A G E N D A

Architectural Review Board

December 20, 2017

PLANNING CONTROLS DIVISION

2023 Madison Avenue

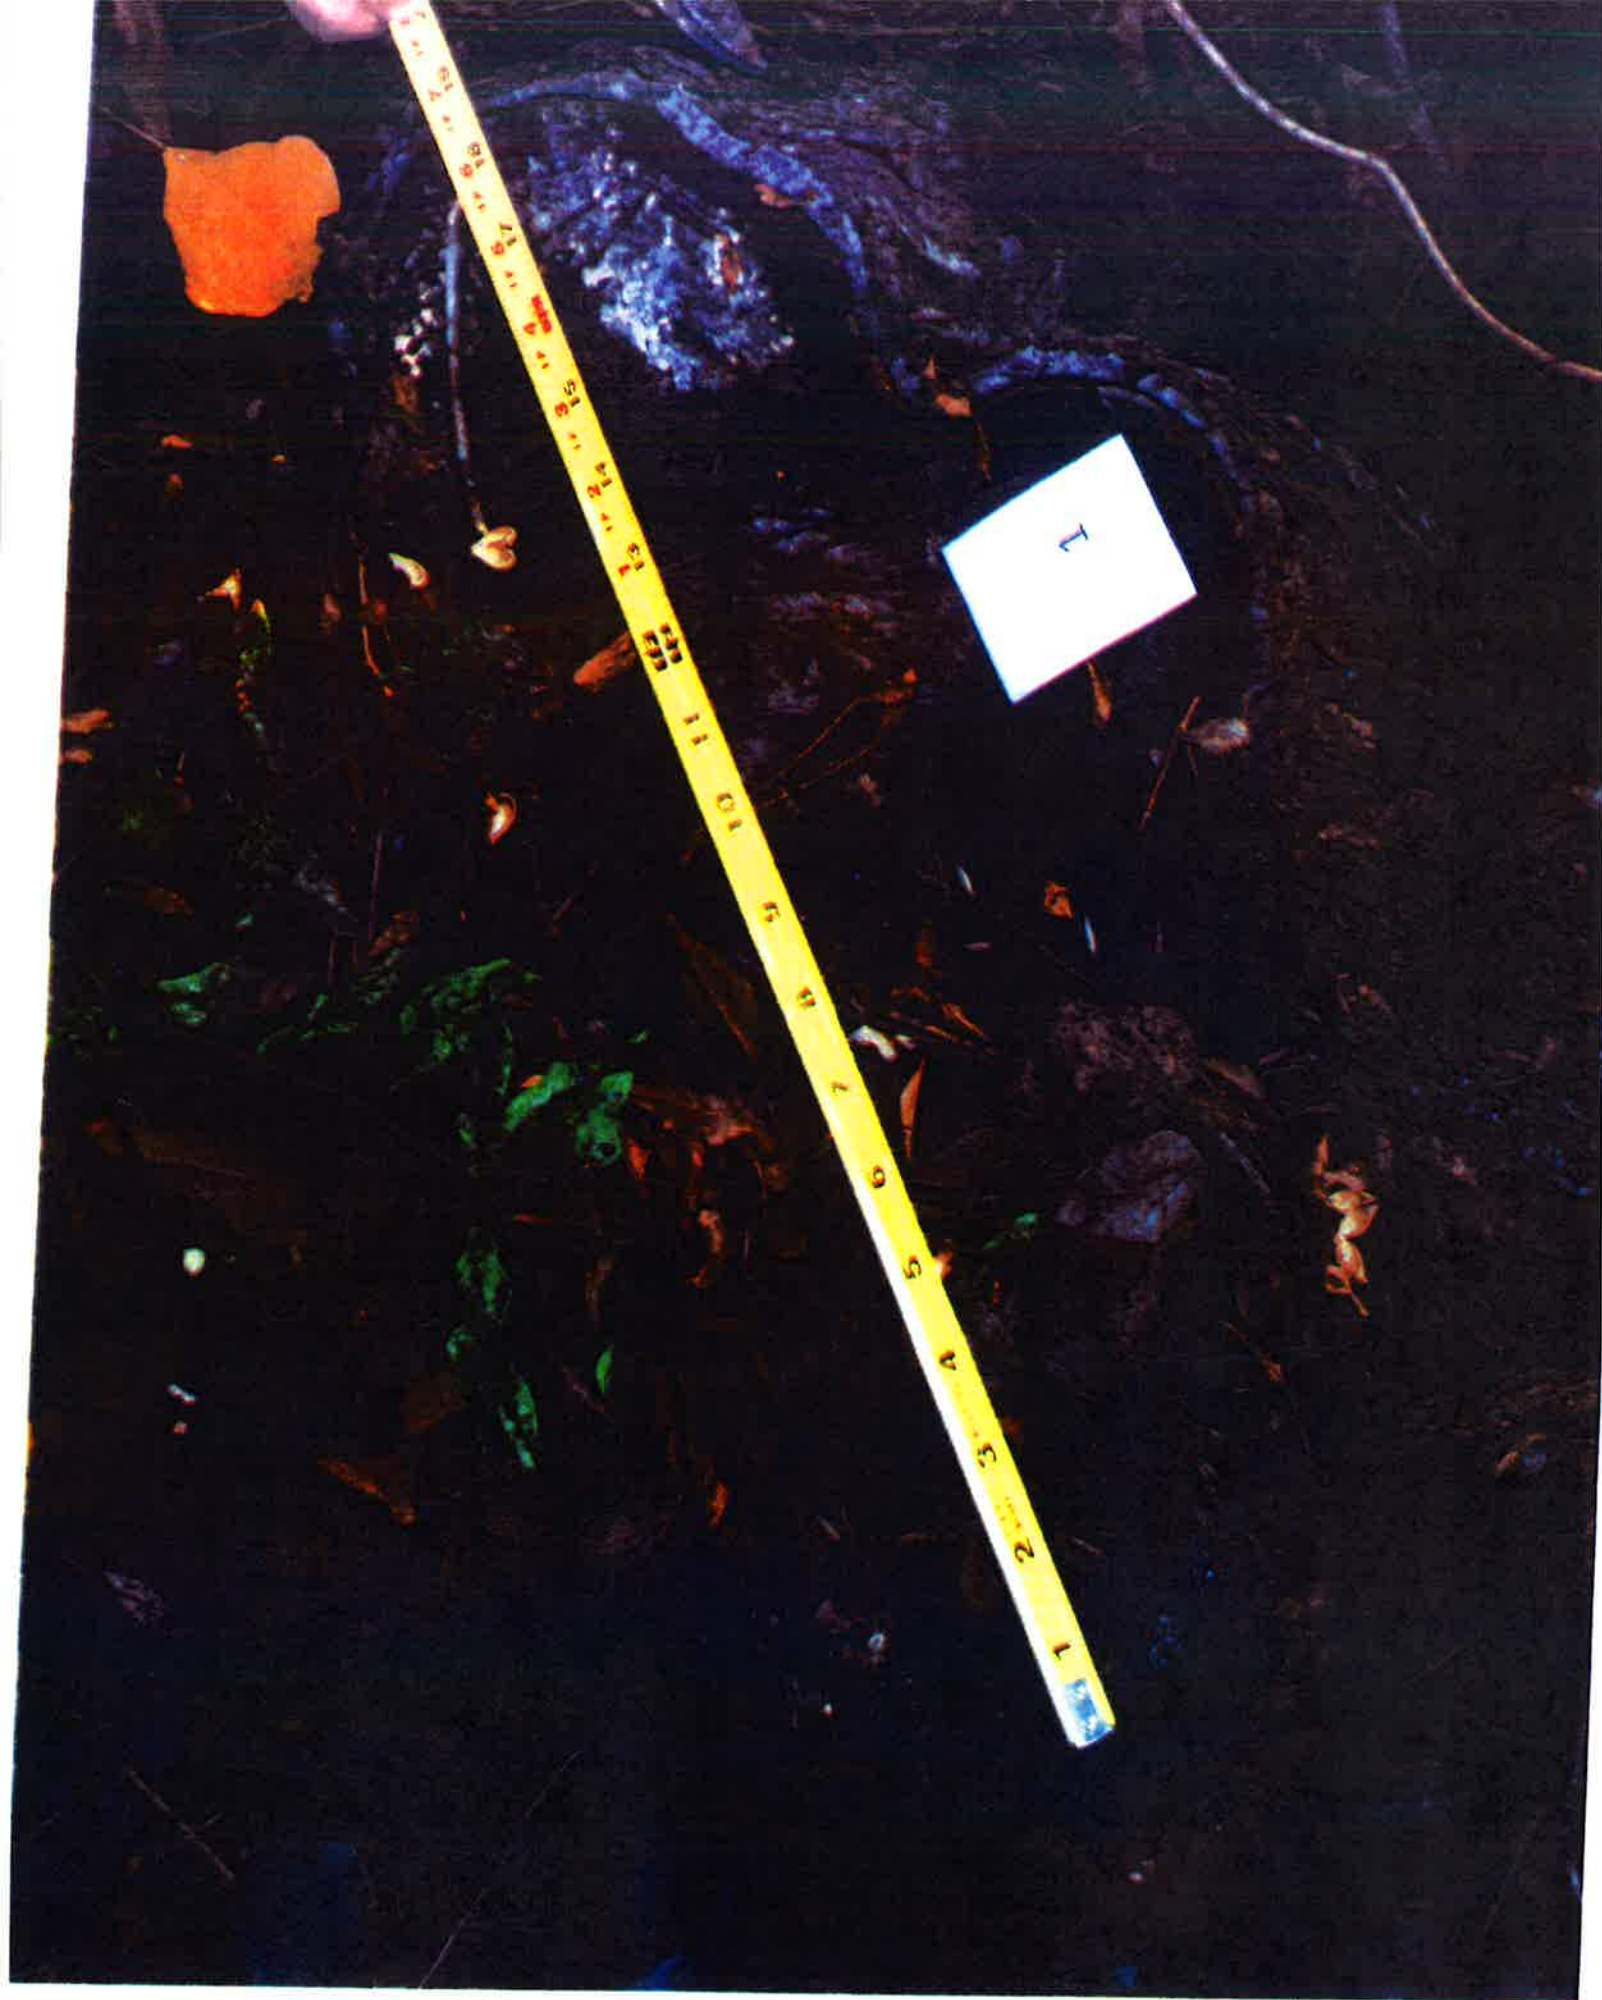
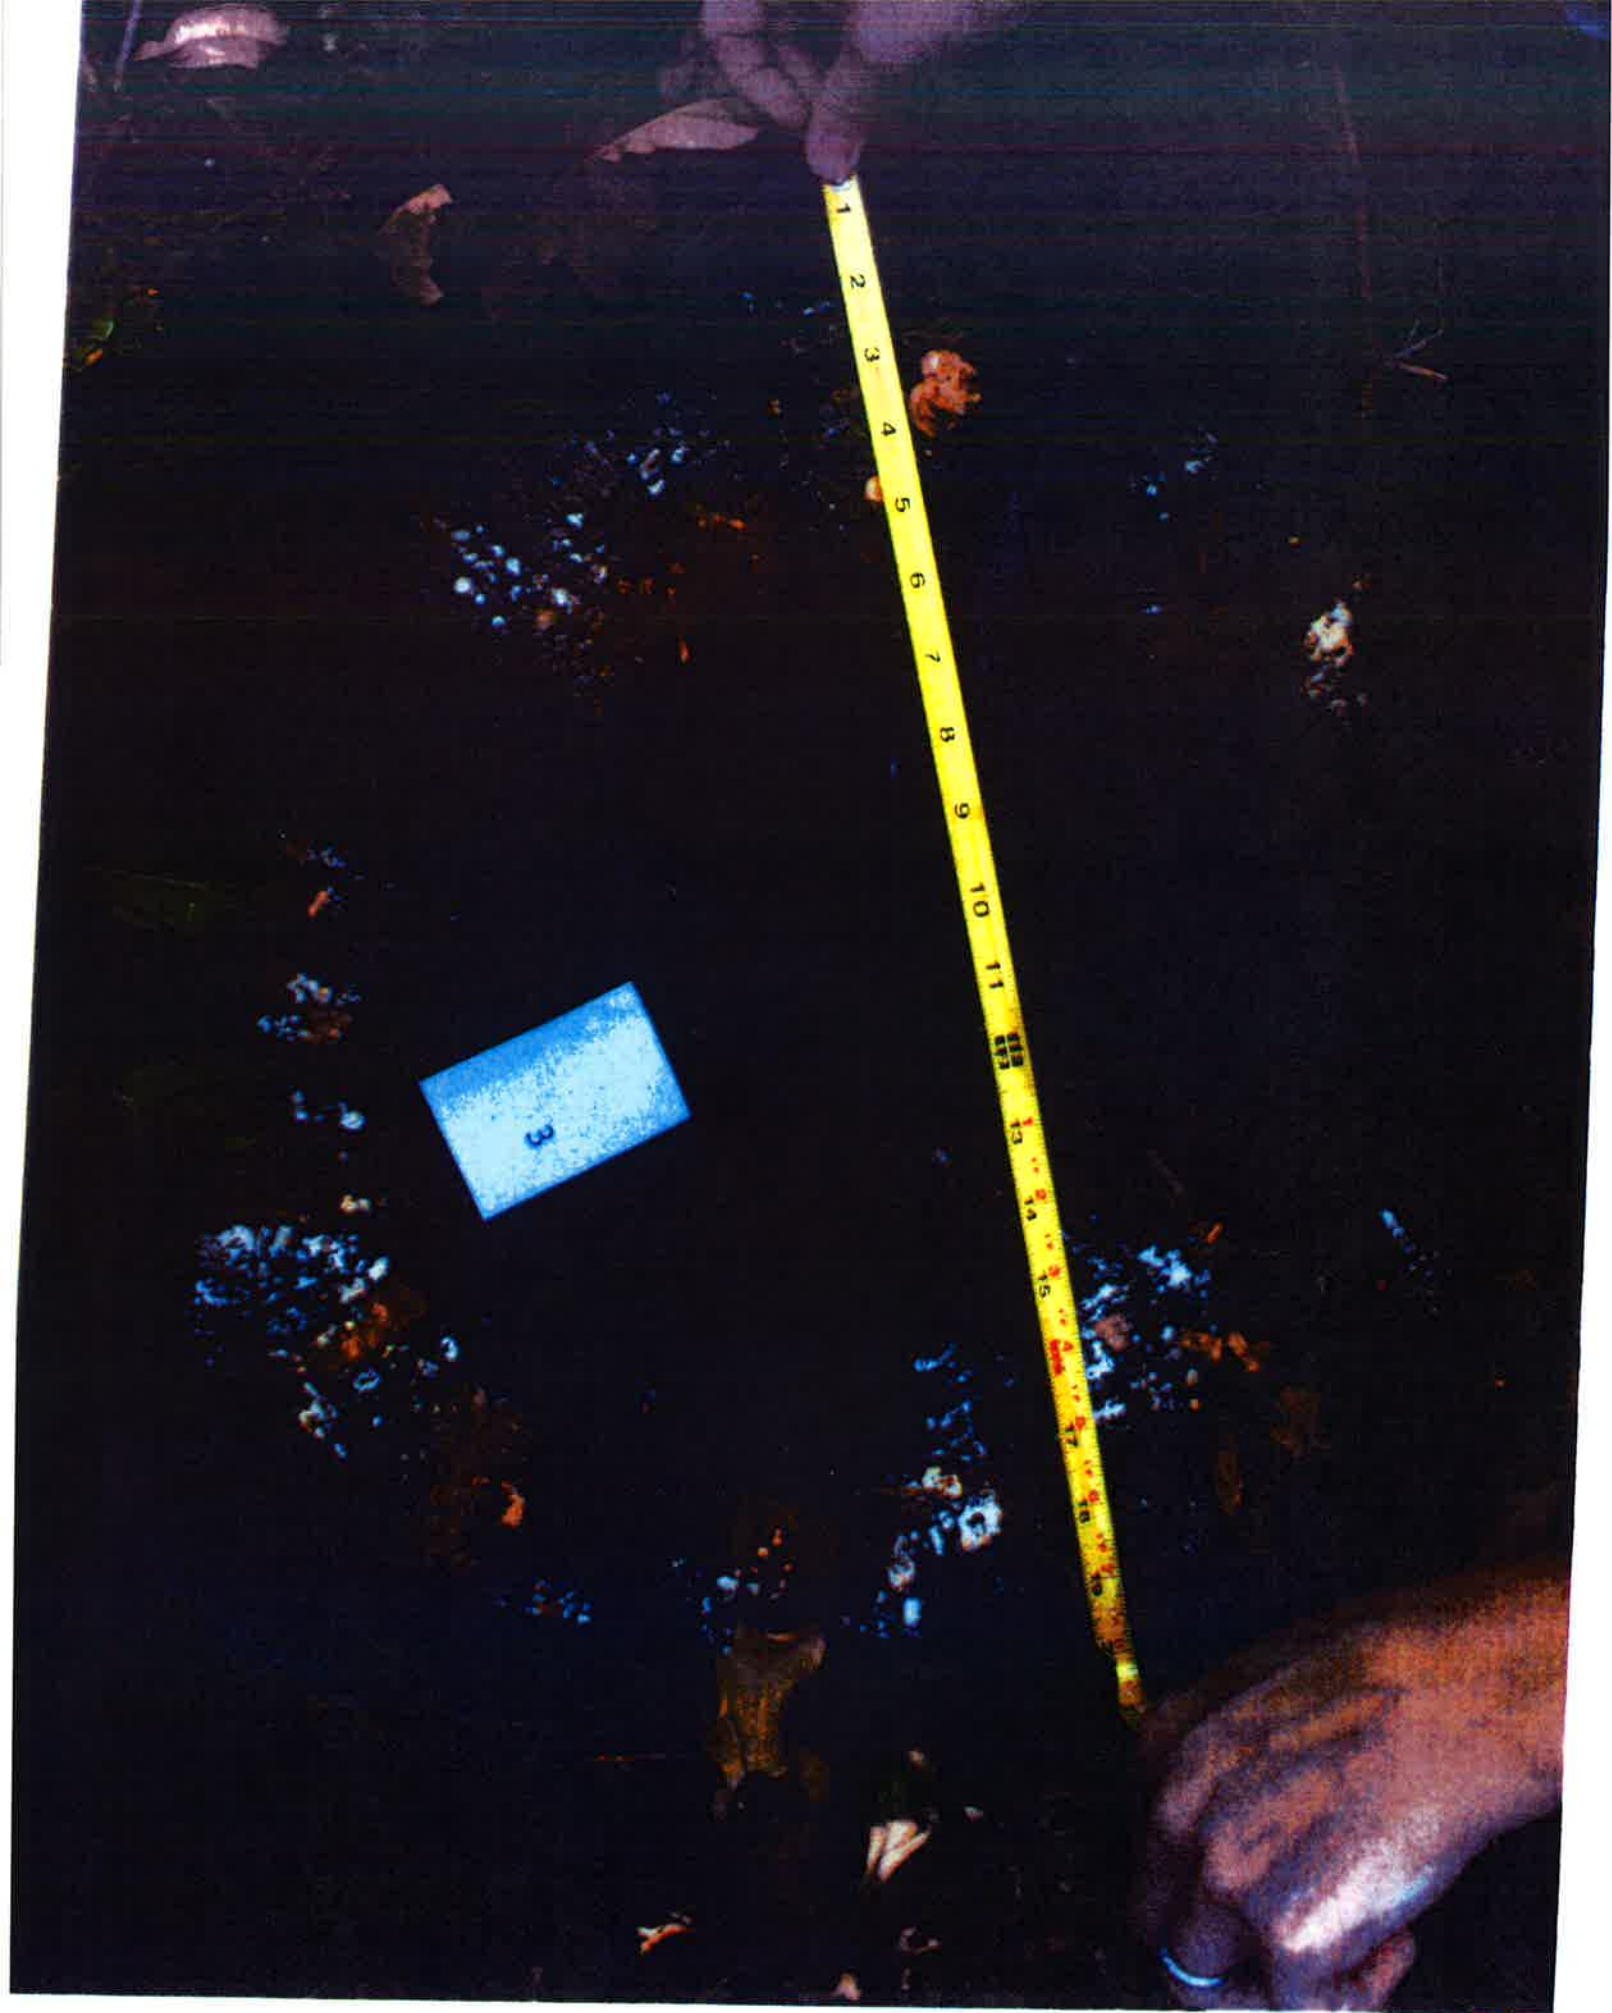
DEPARTMENT COMMENTS

- Replacements should meet size and quality standards from City Landscape Code (2.5" caliper).
